WRITTEN RE-EVALUATION OF THE 2014 FINAL ENVIRONMENTAL IMPACT STATEMENT FOR THE SPACEX TEXAS LAUNCH SITE

Attachment 1. Agency Comments on Draft Written Re-evaluation

Section 106 Consulting Party Comments

Figure 6. Proposed Infrastructure for Control Center Area Parcel 2

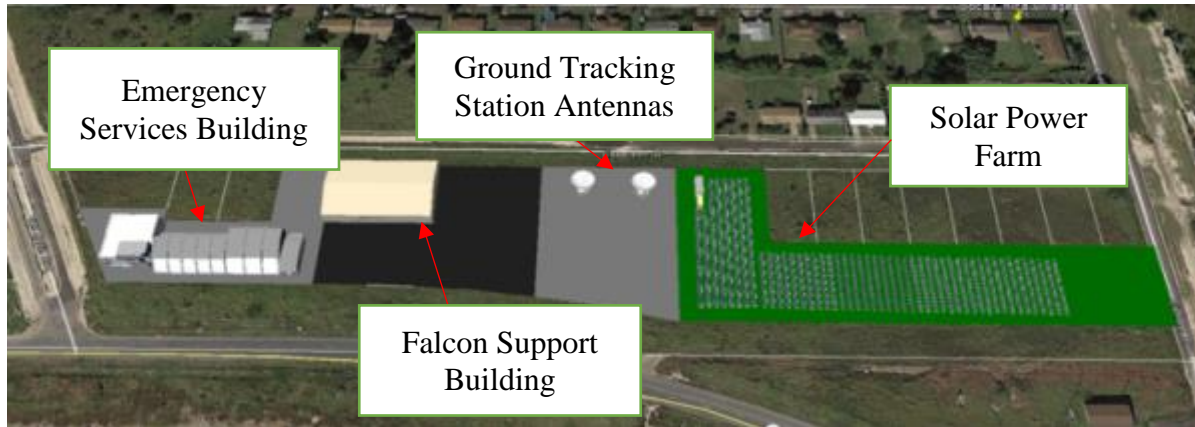
- There is still ambiguity on the location and size of the solar array; only the portion to be built on Parcel 2 is discussed in the WR. There is also an open-ended question on future development of Parcel 3, including the possibility that more solar panels will be built there. This suggests that the project will continue in a segmented fashion with changes and more additions than what has been presented so far.

- The addition of two large structures on Parcel 2 of the Control Center increases the structural density of the Control Center compound and consequently increases the impacts to the viewshed and visual integrity of historic setting (character) of NHL.

NPS	There is still ambiguity on the location and size of the solar array; only the portion to be built on Parcel 2 is discussed in the WR. There is also an open-ended question on future development of Parcel 3, including	The solar array for Parcel 1 is mentioned under the heading “Control Center Area Parcel 1.” The FAA prepared a WR for this solar array in 2014. The solar array will be located within the footprint of Parcel 1. As proposed in 2014, this solar array is expected to be installed on

<p>the possibility that more solar panels will be built there. This suggests that the project will continue in a segmented fashion with changes and more additions than what has been presented so far.</p>	<p>approximately 2 acres of land. The solar array will be approximately 5 feet tall. All solar arrays at the launch site will be composed of non-highly-reflective materials and oriented away from the NHL to avoid any potential visual impact on the NHL (for example, see Figure 8 in the WR). SpaceX has not informed the FAA of any plans to construct in Parcel 3. If SpaceX were to propose installing additional solar arrays in Parcel 3, they would provide the details to the FAA. The FAA would conduct an environmental review, including ensuring compliance with the existing documents in place (e.g., USFWS Biological Opinion, Section 106 PA and MOA) as well as FAA Order 1050.1F. The FAA would coordinate with the Section 106 Consulting Parties as necessary. Any additional solar arrays would likely be made of the same materials as those currently proposed (non-highly-reflective) and oriented away from the NHL, and thus not visible to the naked eye from the NHL.</p>

Figure 10. Proposed Security Fence at the Vertical Launch Area

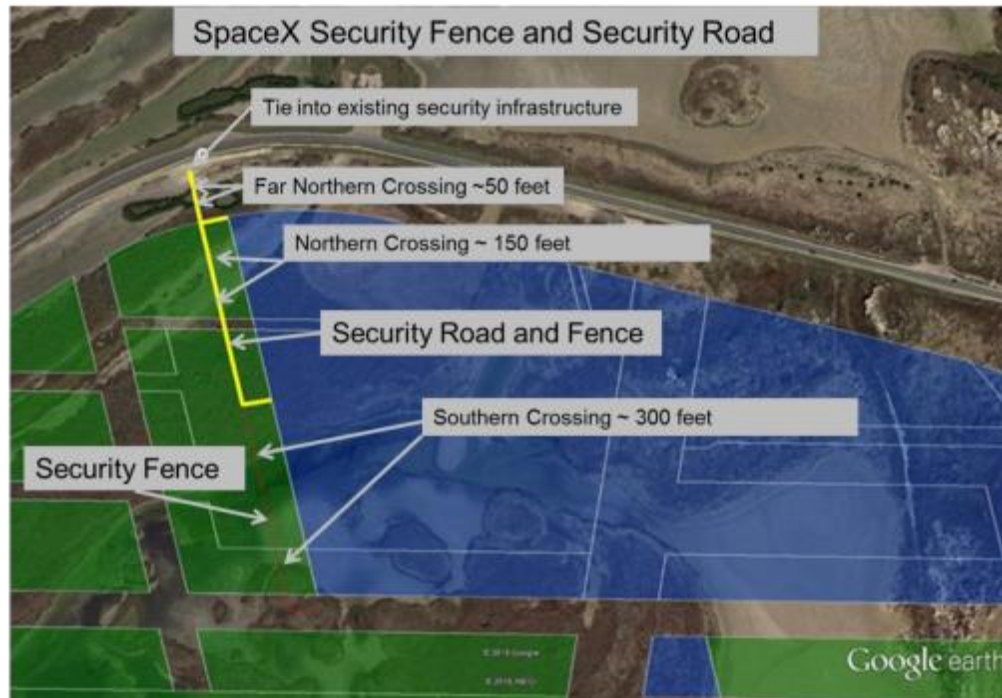
Comment: The acreage is difficult to follow. If the fence is 1,400 feet and 800 feet of associated security road, what portion is being discussed as approximately 199 feet long by 18 feet wide? And if the total wetland security fence impacts 0.082 acres then there are no road impacts?

Comment: The Service agrees there are impacts to piping plover critical habitat with the construction of the fence in the lower southern crossing portion as seen in Attachment A. It is uncertain as to whether the five culverts on the road would cause a change in hydrology that may flow toward the habitat in the south. It may depend on the type of event. We recommend overlaying Attachment A fence and road alignment over Figure 16 of the BO and assess how much acreage of piping plover habitat will be disturbed. Therefore, the Service can provide incidental take for that habitat loss. We also recommend that 500 on each side of the fence inside piping plover habitat be monitored for vegetative changes that may result in the conversion of the habitat as we did in the BO.
